DETAIL OF GUARD RAIL AT BRIDGE APPROACH DETAIL OF REST AREA DETAIL OF U-TURN TURNOUTS

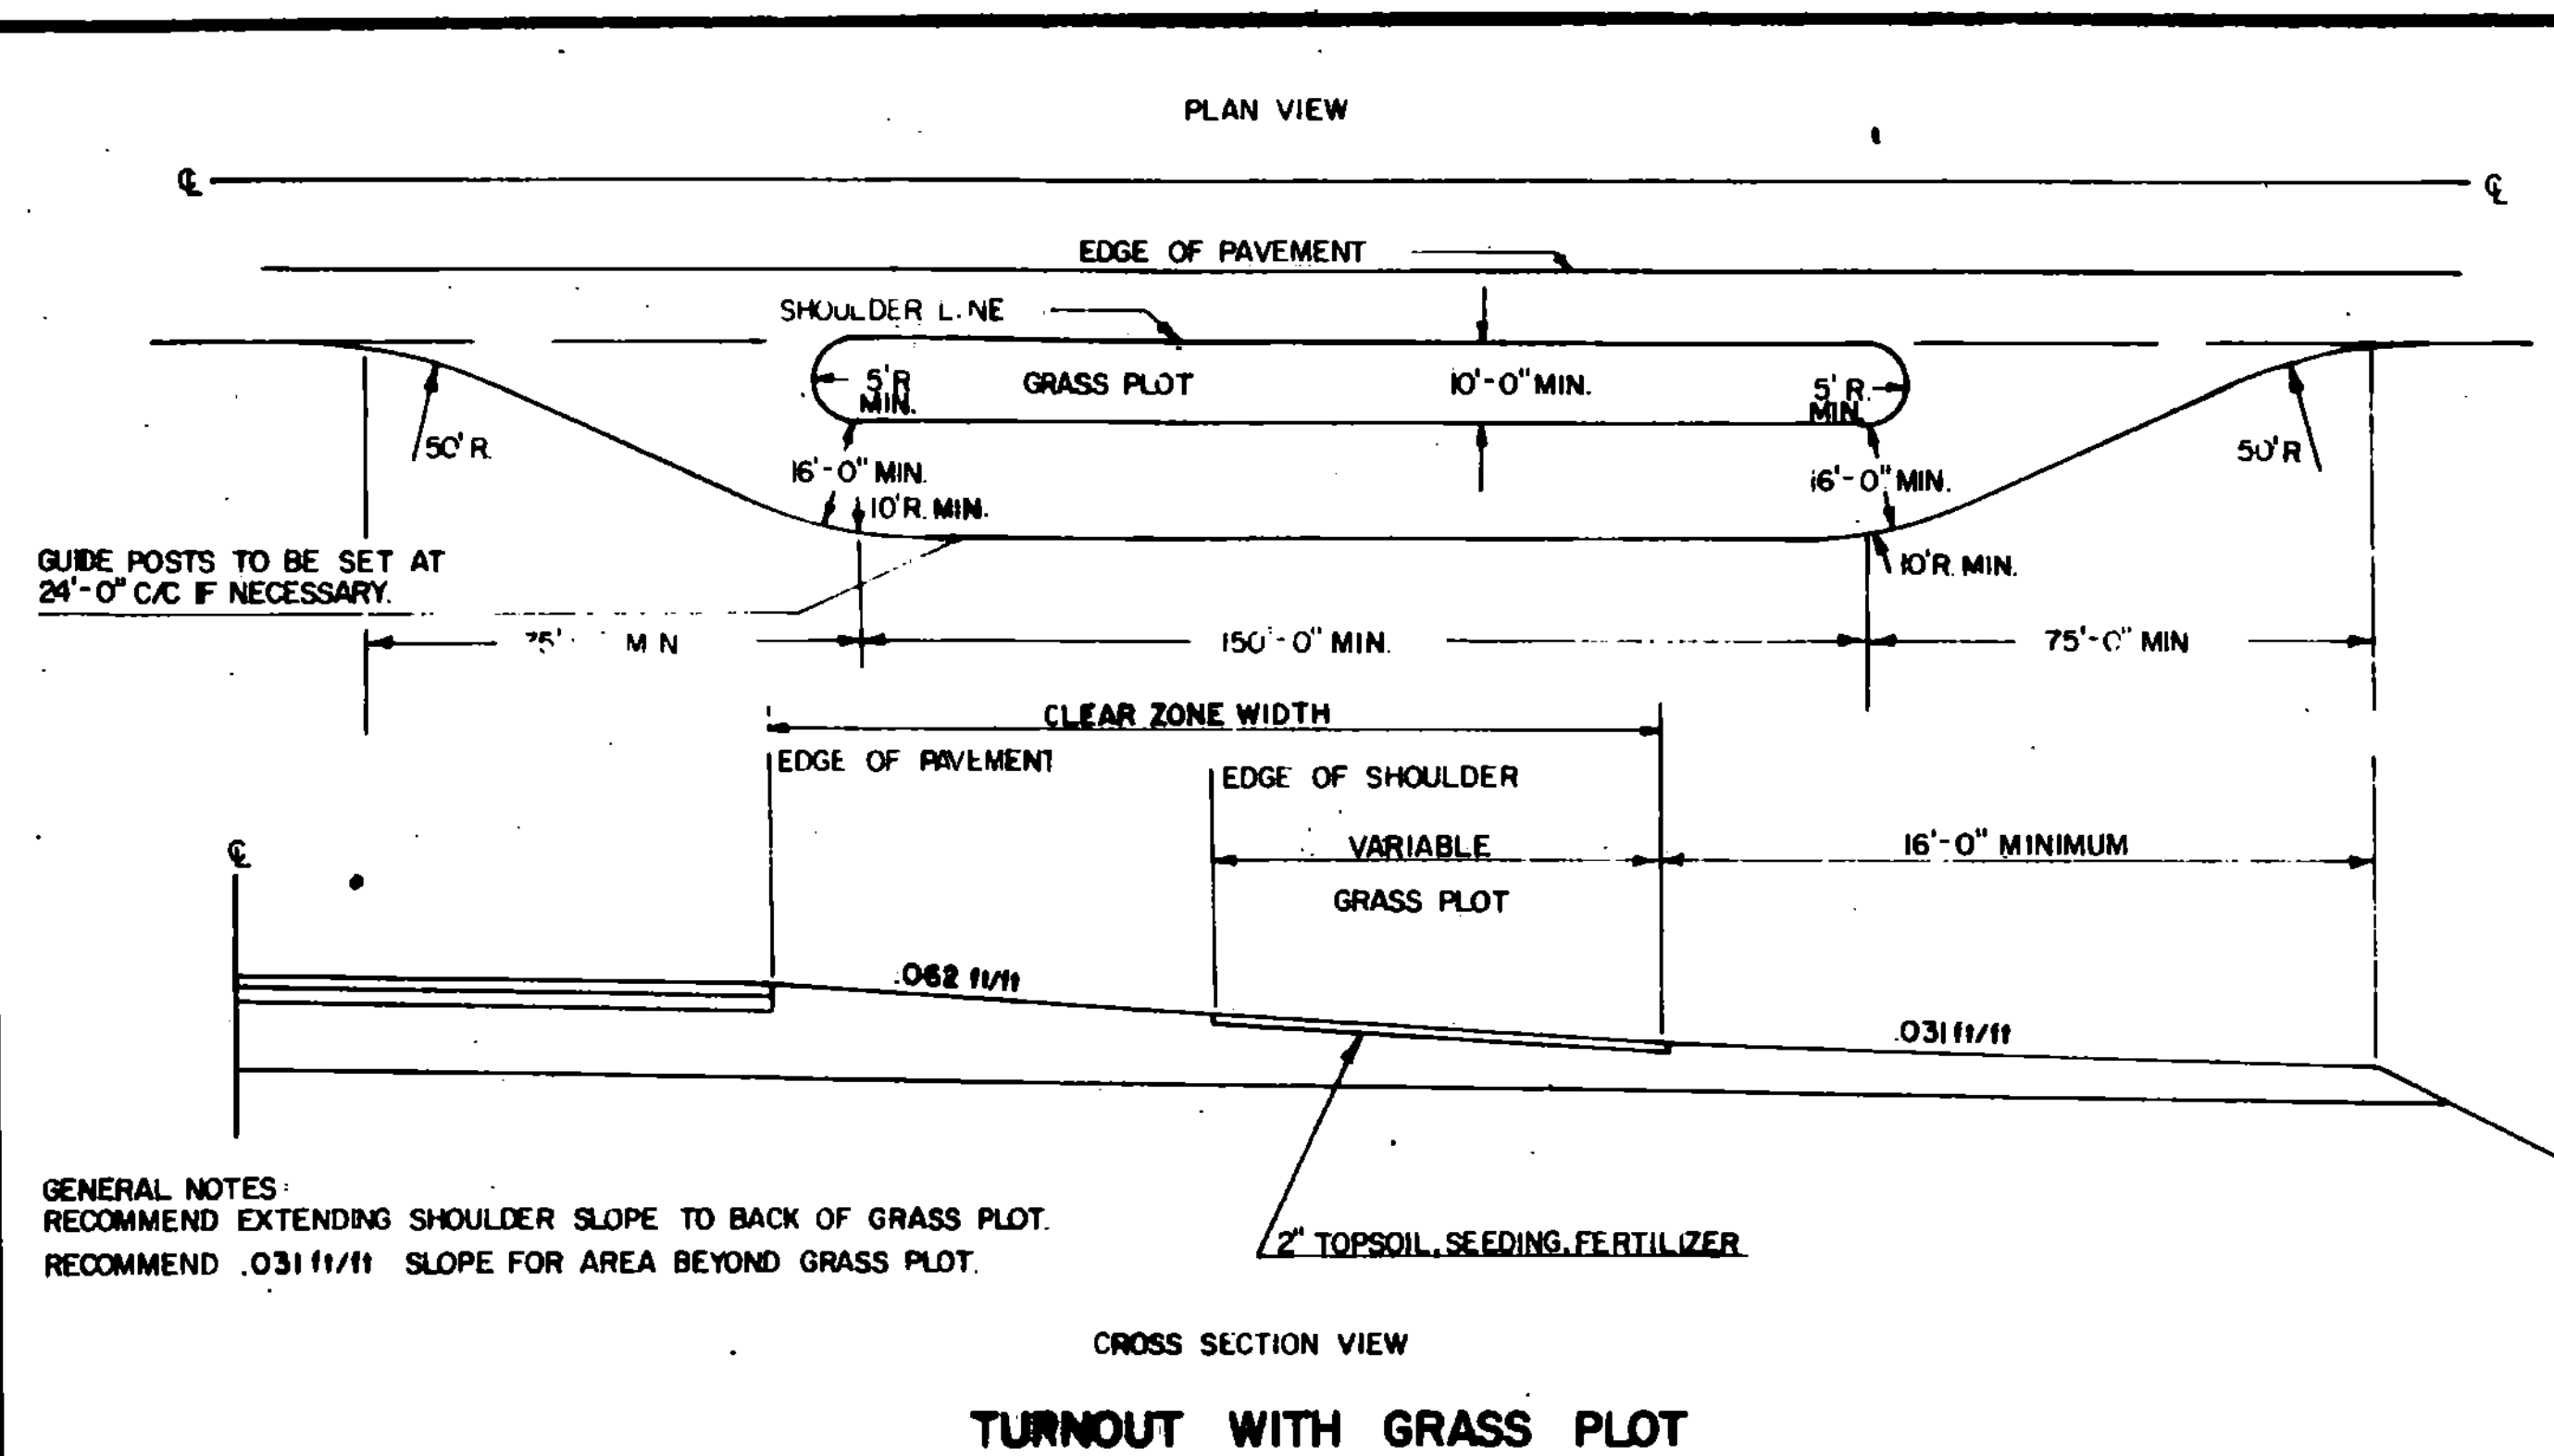
REVISIONS AND CORRECTIONS		APPROVED
DEC. 19, 1972	REFERENCE TO G-8 REMOVED. CEDAR LOG GUARD RAIL REMOVED FROM REST AREA.	DATE: <u>Dec. 8, 1971</u>
JUNE 11, 1973	G-8 ADDED TO EXIT SIDE OF STRUCTURES.	<u>R. H. Arnold</u>
DEC. 16, 1980	INCREASED SHOULDER WIDENING FOR GUARDRAIL; ADDED CLEAR ZONE WIDTH TO DETAIL OF TURNOUT W/GRASS PLOT; ADDED SECTION A-A FOR U-TURN.	CHIEF ENGINEER
OCT. 25, 1985	REVISED TO CONFORM TO 1986 SPECIFICATIONS, GUARD RAIL AT BRIDGE APPROACHES	<u>E. H. Stikney</u>
		ASST. CHIEF ENGINEER
		<u>G. M. Lane</u>
		HIGHWAY ENGINEER
